## 112432 - 00

**Change Notification #:** 112432 - 00  
**Change Title:** Intel® NUC Kit DCCP847DY, Boxed  
PCN 112432-00  
Product Design and Documentation,  
Change Bottom Cover, Update Attention  
Flyer and Integration Guide  
**Date of Publication:** July 11, 2013

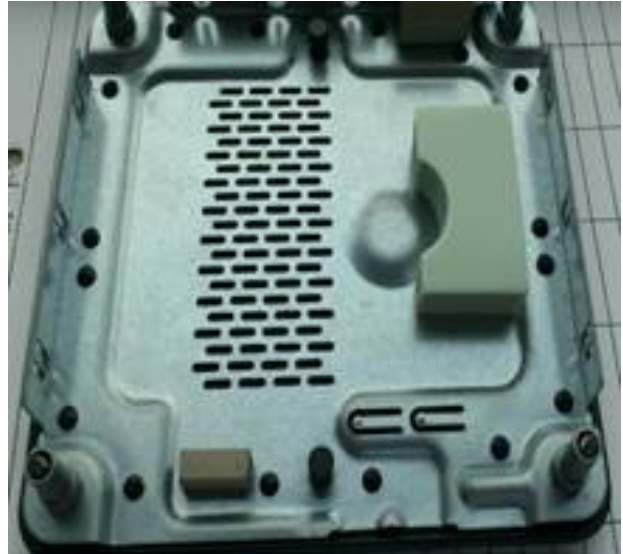
Intel will be upgrading the bottom cover to include a 9.5mm thermal pad to enhance the thermal design.

Current Bottom Cover:

New Bottom Cover:
